**Recommendations of the Risk Informed Steering Committee
Working Group on PRA Technical Adequacy**

March 2015

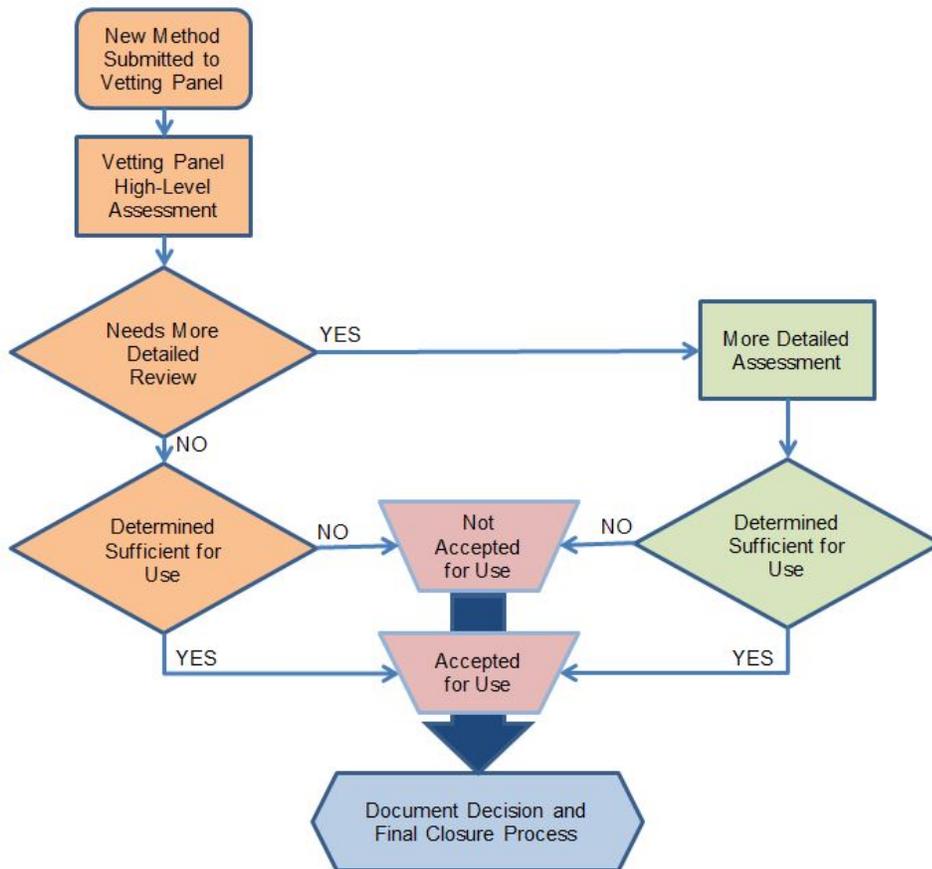
Comment [NRC9]: The narrative about the vetting panel needs to come before or have integrated into it the description of the process options.

Comment [NRC10]: The NRC agrees that more detailed guidance (similar to Appendix 1) is needed as part of the pilot process to determine its practicality and revise the guidance as appropriate.

However, for this part of the discussion in the whitepaper, the NRC staff considers a high-level conceptual flowchart to be more useful for explanatory purposes.

See recommended insert.

Comment [NRC14]: As written, this appears to be inconsistent with the Appendix 1 figure. This description seems to imply that a method that does not pass a peer review or meet RG 1.200 in a gap assessment can still be used by a licensee in an application so long as the licensee addresses the failings of the method, as identified in the peer review or gap assessment. The Appendix 1 figure implies that such a method would not be accepted for use.

Suggest discussing on 3/30 – Industry can rearrange, but prefers to finish resolving comments before undertaking this.
